APPENDIX D
Minutes of Stakeholder Meetings
and Staff Team Meetings

PROJECT: Longwood Road – Schedule C - Class Environmental Assessment
PROGRESS MEETING NO: MTO Coordination Meeting #1
FILE NO.: 7621
DATE: February 8, 2010 **TIME:** 2:00 p.m.
PLACE: Hamilton City Centre – DPW Offices
PRESENT: Lorissa Skrypniak - Public Works
Ron Gallo - Public Works
Tanya McKenna - Public Works
Steve Robichaud - Planning
Bart Brosseau - Public Works
David Cuming - Urban Design
Khaldoon Ahmad - Urban Design
Richard Yeung - MTO Corridor Control
Greg Roszler - MTO Corridor Control
Philip Weber - Ourston Roundabouts Canada
Ted Gill - MRC
PURPOSE: Coordination with MTO

PROJECT: Longwood Road – Schedule C - Class Environmental Assessment

PROJECT: Longwood Road – Schedule C - Class Environmental Assessment

- existing road allowance
- Longwood OP Widening
- DRAFT Primary Care building footprint
- property requirements – ultimate conventional
- property requirements – ultimate roundabout

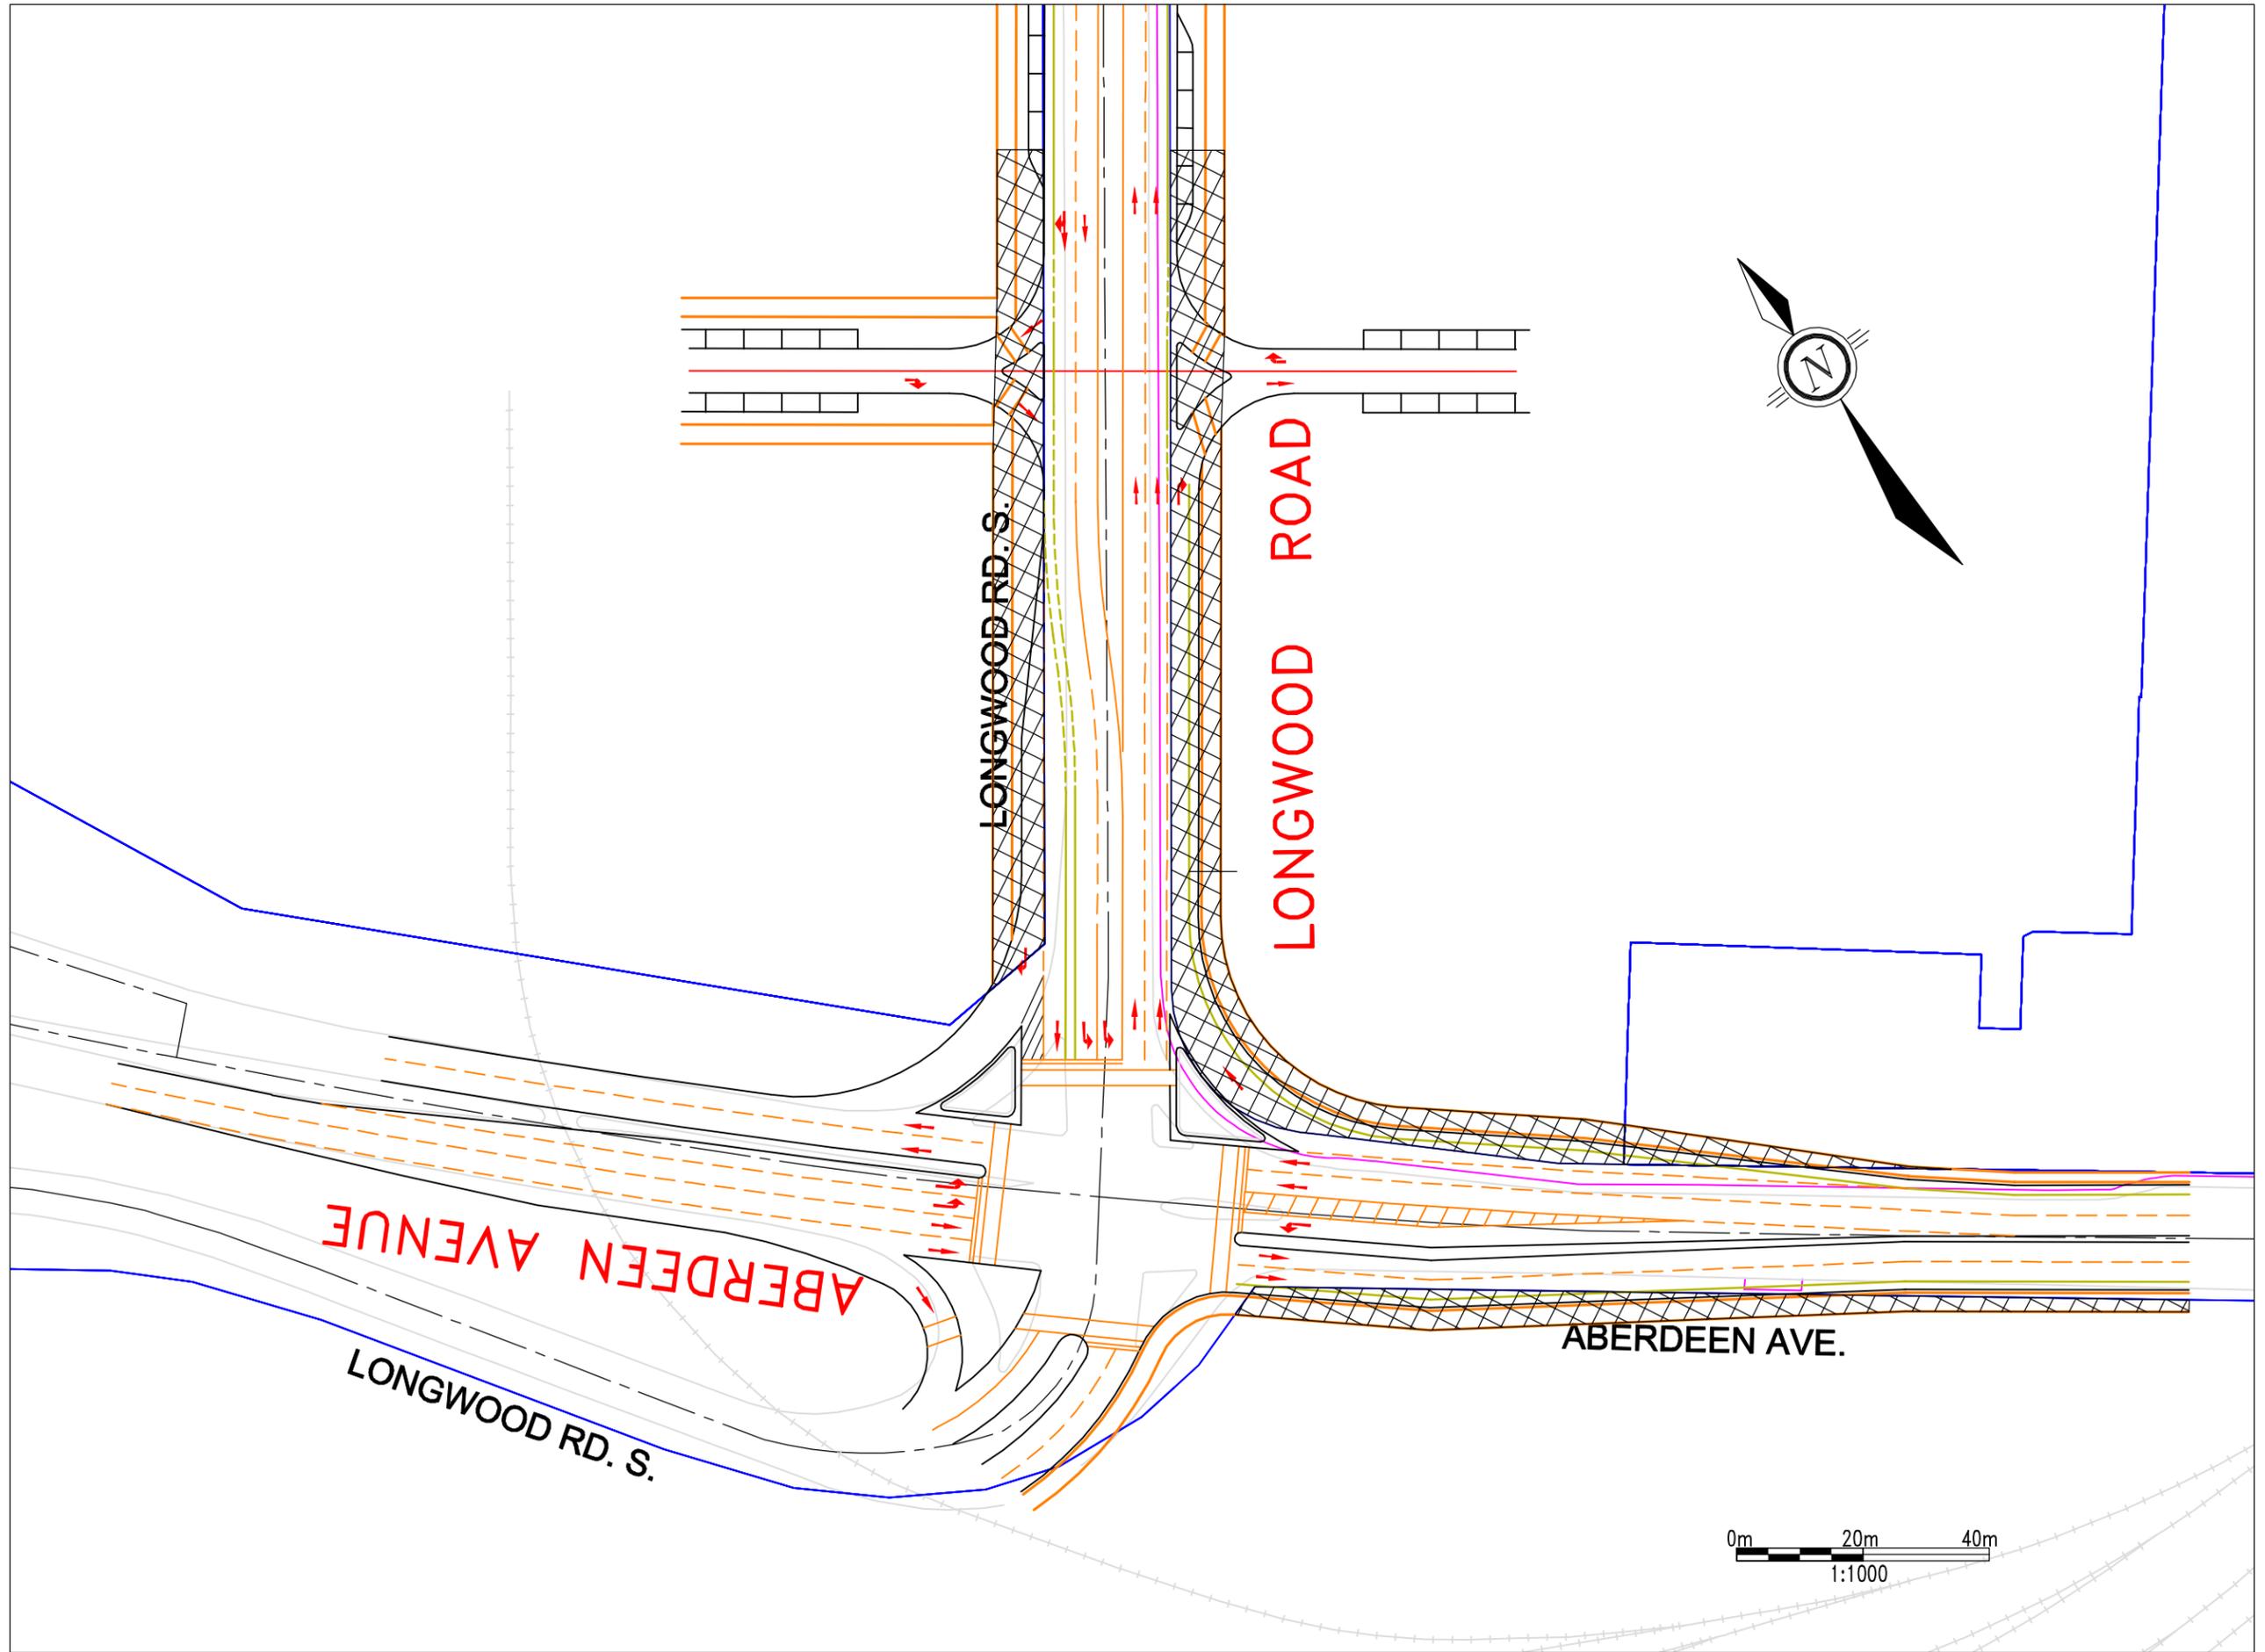
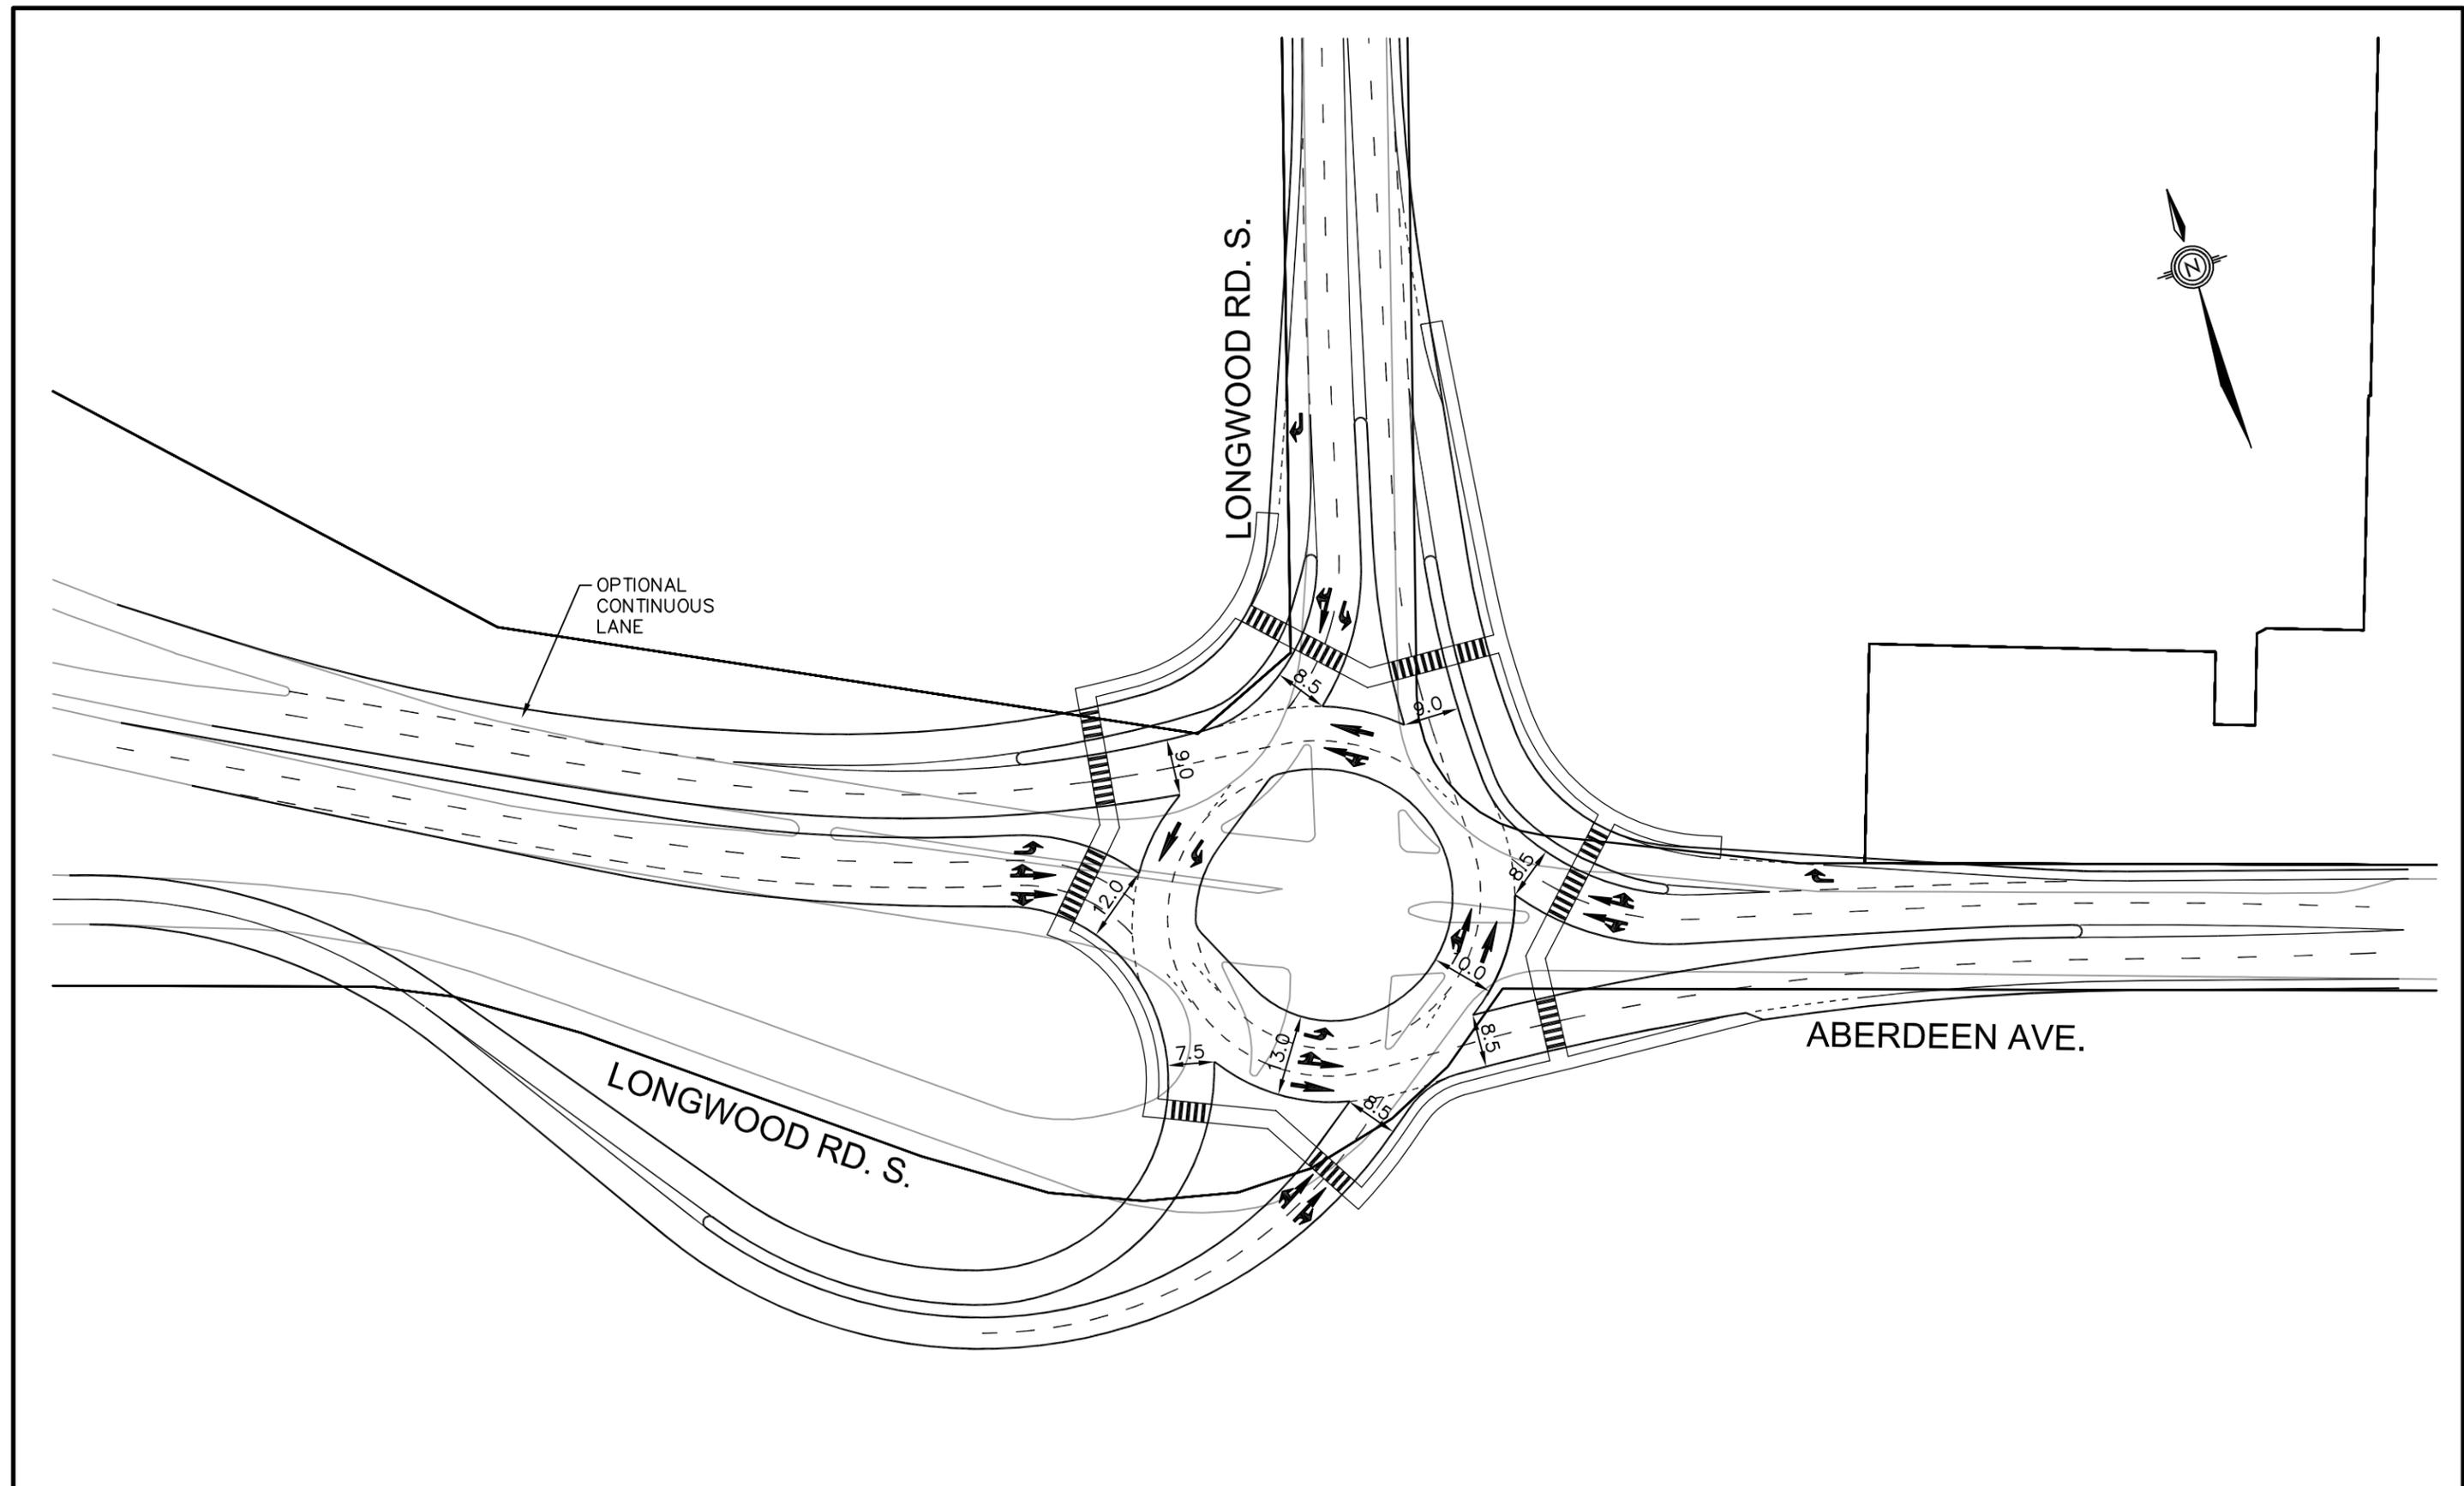
- Ted Gill presented a series of PowerPoint illustrations showing the property requirements on Longwood Road to give effect to the Official Plan designation of 36m, the property requirements for an ultimate conventional intersection design, and the property requirements for an ultimate roundabout design incorporating right turn slip lanes for WB to

- NB movements and SB to EB movements. The proposed location of the McMaster Primary Care Facility was also shown.
- Zach Douglas objected to the extent of the widenings for the ultimate roundabout configuration because of the impact on McMaster Innovation Park developable land on the east side of Longwood Road. He indicated that MIP has more flexibility with respect to additional property requirements in the NW quadrant on the west side of Longwood Road between the existing building and Aberdeen Avenue.

- Orest Rojic and Richard Yeung expressed concerns with the slip ramps, indicating that weaving distances would be very short. Phil Weber provided the rationale for the design, indicating that “smart ramp” design could possibly be used for the ramp designs, and that no ramps would be required for a number of years. Phil described how pedestrians and cyclists would be accommodated. Tanya McKenna explained that a signal was to be provided at Studholme where pedestrians and cyclists could cross Aberdeen.

- Discussions occurred re shifting the roundabout southerly and westerly, but there was a constraint with respect to truck movements and loading at the building located on the CP lands. Phil Weber stated that when designing a roundabout, the design is optimized for entry and departure angles etc., after which variations in location by a relatively modest distance (usually just several metres) can be considered to address specific constraints. It was concluded that the study team will investigate the extent to which a southwesterly shift could occur.
